## CITY of NOVI CITY COUNCIL

Agenda Item 1  
July 21, 2014

**SUBJECT:** Consideration of a request from CZ Cartage, Inc. for a variance from Section 11-239(b) of the Design and Construction Standards of the City Code, which requires parking areas and maneuvering lanes to be hard-surfaced and curbed, to allow the applicant to construct a parking area that is gravel surfaced on parcel number 22-17-101-006.

**TO:** VICTOR CARDENAS, INTERIM CITY MANAGER  
**FROM:** ROB HAYES, P.E.; PUBLIC SERVICES DIR/CITY ENGINEER  
BRIAN COBURN, P.E.; ENGINEERING SENIOR MANAGER *BTC*  
**SUBJECT:** CZ CARTAGE VARIANCE REQUEST—ENGINEERING RESPONSE  
**DATE:** JULY 16, 2014

PRELIMINARY SITE PLAN

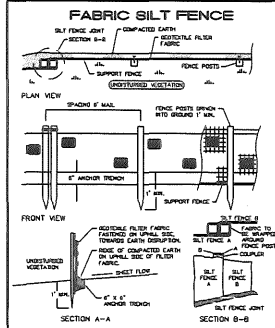
VARIANCES WILL BE REQUESTED FOR NON HARD SURFACE PAVING AND DELETION OF CURBS.

The applicant's plan shows that the parking lot would be constructed within 50 feet of a regulated wetland. Curb, gutter and storm catch basins are not proposed on the plan to guide and direct the flow of storm water within the parking area. Instead, the applicant is proposing to sheet flow the parking lot drainage into the sedimentation and detention basin. Based on past experience, staff has concerns with the sheet flow of large areas of parking lot because of the erosion that will likely occur at the edge of the parking area. The lack of pavement to stabilize the surface of the proposed parking area increases the concern for erosion of material from the parking lot and sedimentation of not only the detention basin, but transport and deposition of suspended solids into the adjacent wetlands that receive the flow from the detention basin. Asphalt millings have been used in the City as a base material under a paved surface. We have some concern with the use of asphalt millings as a surface material because of the residual oil in the asphalt millings could potentially leach into the adjacent storm water and wetland areas. For these reasons, we believe that granting the variance would be detrimental to public health and could impact wetlands on adjacent properties.
